Application for Works Approval

| Works Approval Number | W6820/2023/1 |
| Applicant | Tyrecycle Pty Ltd |
| Premises | Tyrecycle Rockingham 371 Mandurah Road EAST ROCKINGHAM WA 6168 Legal description - Part of Lot 850 on Deposited Plan 415740 As defined by the coordinates in Schedule 1 of the works approval |

Figure 2: Premises access points and tyre storage bunkers

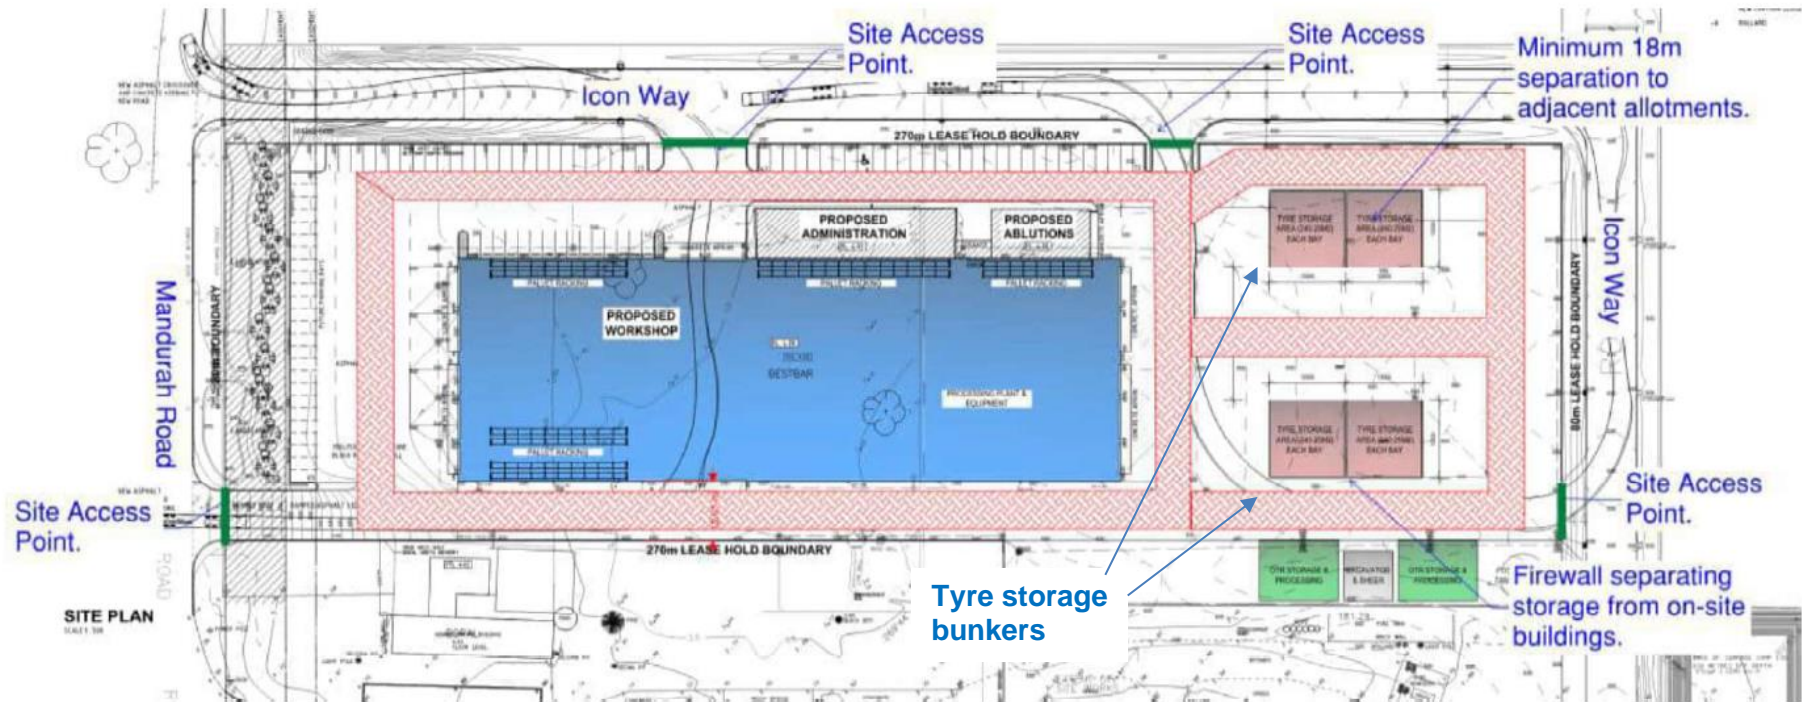
The applicant intends on maximising the quantity of tyres and cut rubber pieces being reprocessed at the premises above the limit provided for by DFES GN02. To do this they intend on maximising the available storage inside the warehouse and outside in the yard. The applicant commissioned a specialist fire consultant to design the yard and warehouse areas and the fire prevention methods to meet the additional requirements of DFES and the relevant Australian Standards. After consultation with DFES the following tyre storage requirements have been tailored for the premises (Figure 2):

- There will be a limit of four bunkers at the premises for storage of tyres which will be located on the eastern side of the yard;
- Two tyre bunkers shall be constructed side-by-side, and facing opposite a second set of two side-by-side tyre bunkers that are set 18 m away;

- Fire walls will be installed to the three sides of the bunkers, with the fourth side being open and facing inwards towards the other pair of bunkers;

- Tyres stored within the bunkers will be limited in height to 2.7 m, with this height being demarcated by a visible line on the internal sides of the fire walls;

- Internal fire walls that separate a pair of tyre bunkers will be constructed to a height of 4.85 m and rated to a fire resistance level of 240/240/240;

- External fire walls that face the warehouse will be constructed to a height of 3.0 m and rated to a fire resistance level of 180/180/180, plus maintain a separation distance of 18 m from the warehouse; and

- External fire walls that face the premises boundary will be constructed to a height of 3.0 m and rated to a fire resistance level of 180/180/180, plus maintain a separation distance of 6 m.

| Condition / Section | Summary of applicant's comment | Department's response |
|------------------------------------|---|---|
| Section 2.3 | The external walls of the tyre bunkers will be constructed to 3.0 m high, while the internal fire wall dividing one bunker from the adjacent one will be constructed to 4.85 m high. The fixed monitor system and in-rack sprinklers were discussed at the recent DFES meeting. It was confirmed the system is not required for DFES purposes or building construction requirements. In negotiation, the applicant has committed to using open-frame racking that is limited in height to below 7 m to negate the need for in-rack sprinklers. The calculated volume of firewater required for an indoor fire event is incorrectly described as 432,000 L: the correct volume is 1,173,140 L. | Report amended. Works Approval condition 12, Table 5 will be amended for consistency with the open-frame racking being limited in height to below 7 m. |

Figure 3: Premises firewater containment infrastructure

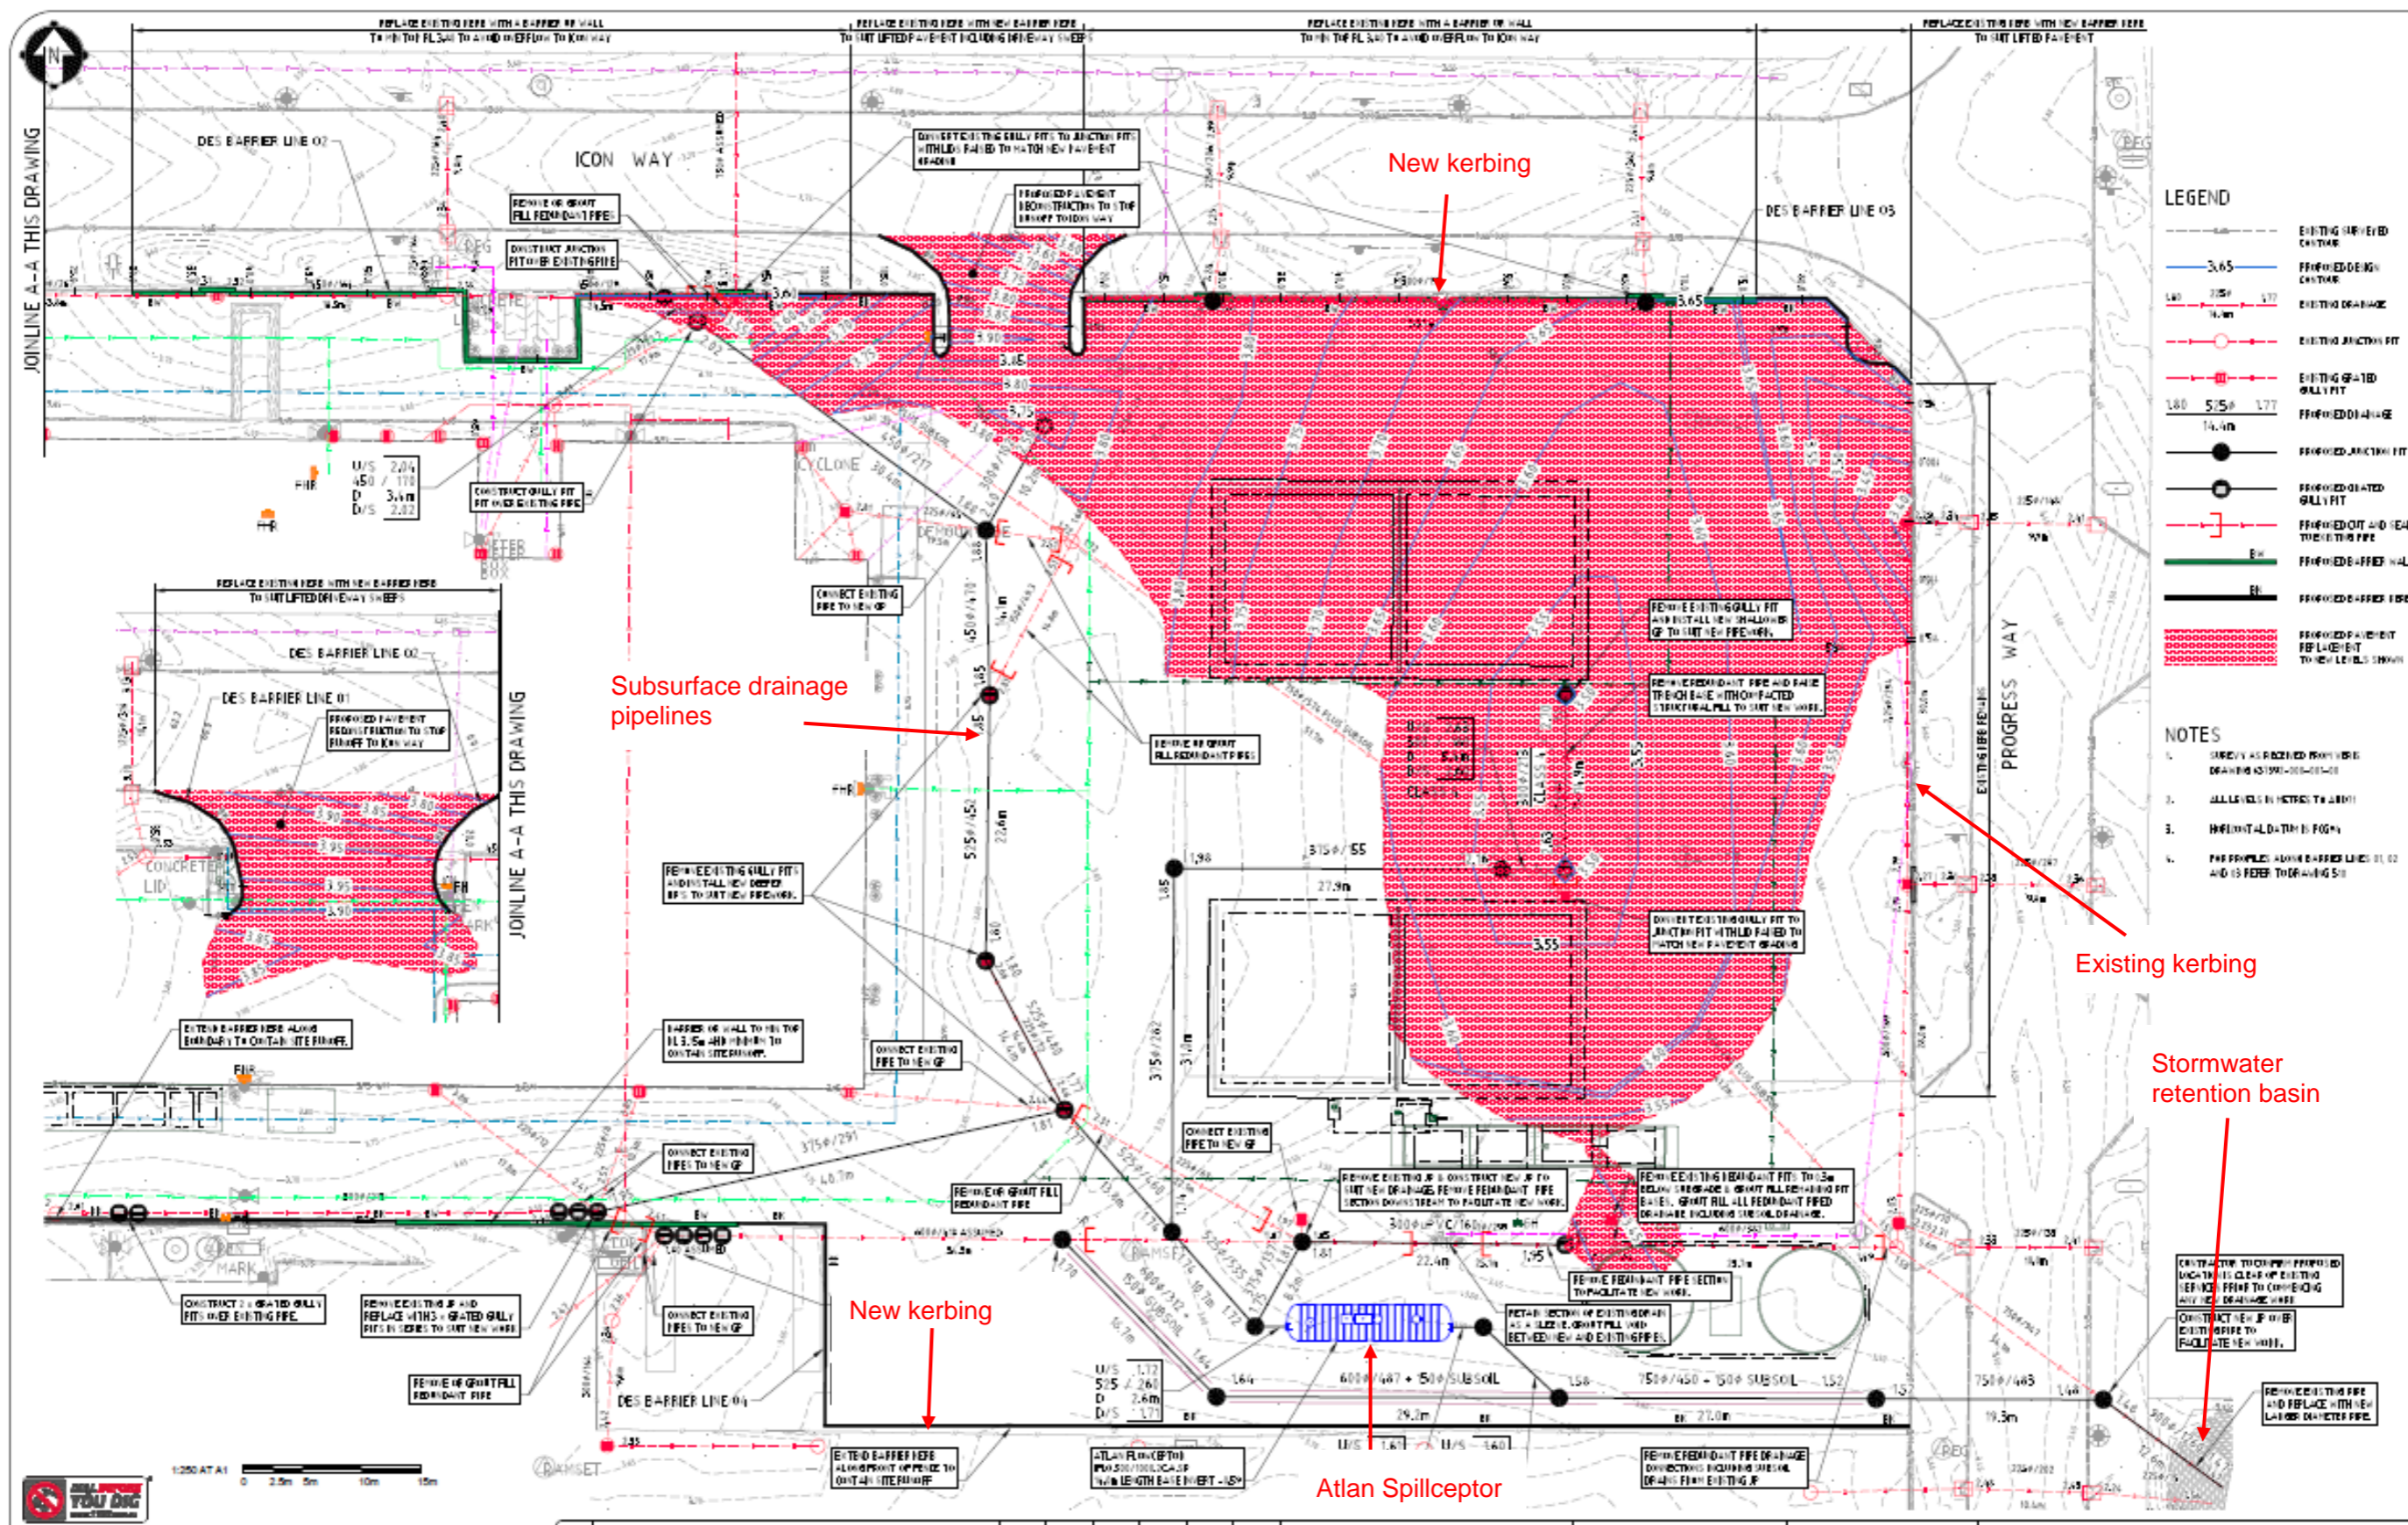
The calculated volume of firewater required for an indoor fire event is 1,173,140 L and for an outdoor fire event is 1,080,000 L. The applicant intends on installing barrier kerbing along all external fence lines and boundary lines to contain all contaminated firewater within the premises, as well as any stormwater. Contouring of the external bitumen yard areas will direct all firewater away from the premises boundaries and driveway crossovers and into the subsurface drainage pipeline network. It will then be piped through an Atlan Spillceptor, a subsurface filtration tank to be installed on the southern side of the yard (Figure 2).

The Atlan Spillceptor will function in the event of a power failure as it is a gravity fed system. The Spillceptor has been designed to filter 260 L/sec, which is sufficiently sized to keep up with the rate of firewater generation. All wastewater is filtered through the system, there is no by-pass operation. The inlet dip pipe is a flame trap to prevent fire and flammable vapours passing through the filtration system. The tank consists of two horizontal treatment chambers to retain light liquids in all flow conditions. The first chamber traps total suspended solids, silt, sediments, sludge and gross pollutants which settle on the chamber floor and where light liquids are contained. The second chamber further separates off oils and hydrocarbons, achieving a water discharge quality of 5 mg/L or less of oils and hydrocarbons.

Once the firewater has passed through the filtration system and all contaminants are filtered out, filtered water will be discharged to the southeastern corner of the premises into an existing stormwater infiltration basin located on the boundary of the premises and the adjacent Lot 804. The same owner owns the subject premises land and Lot 804 and has given permission for the discharge of water to occur.

Based on this amount of internally stored tyres and product, the calculated volume of firewater is 150,000 L. This volume can be sufficiently contained within the yard contouring and drainage infrastructure, minus the use of the Atlan Spillceptor. The drainage system will be securely sealed off at the point where it is intended for insertion into the Spillceptor, and at the exit point from the premises to the infiltration basin, to ensure all contaminated water is retained within the premises.

Figure 4: Monitoring locations of warehouse stacks

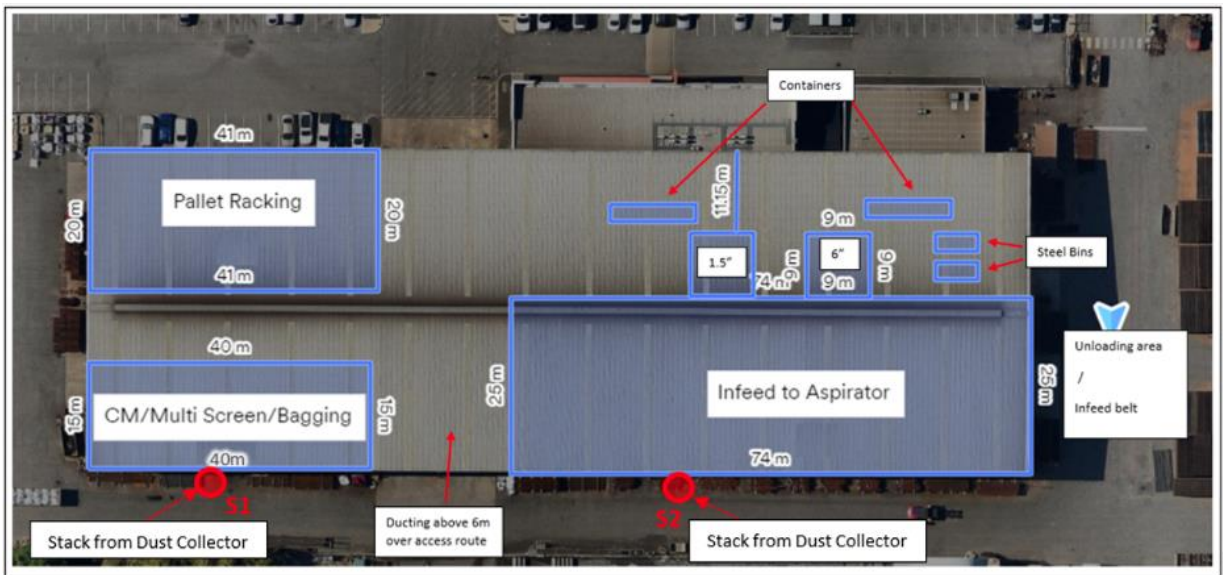
The Applicant has since determined that infrastructure limitations will prevent a 14 m height for the two stacks. A revised Air Quality Assessment report modelled particulate emissions from a number of varying stack heights and determined that a height of 5.2 m will continue to meet the above air emission levels (Todoroski, 2023).

3. The Delegated Officer notes monitoring should be conducted to confirm particulate emissions during operation of the premises remain within allowable levels.

| Condition / Section | Summary of applicant's comment | Department's response |
|------------------------------------|---|---|
| Condition 19 Table 7 | Discharge point height for particulate matter: insertion of 'minimum' into the height specification of the discharge point. | Condition amended. |
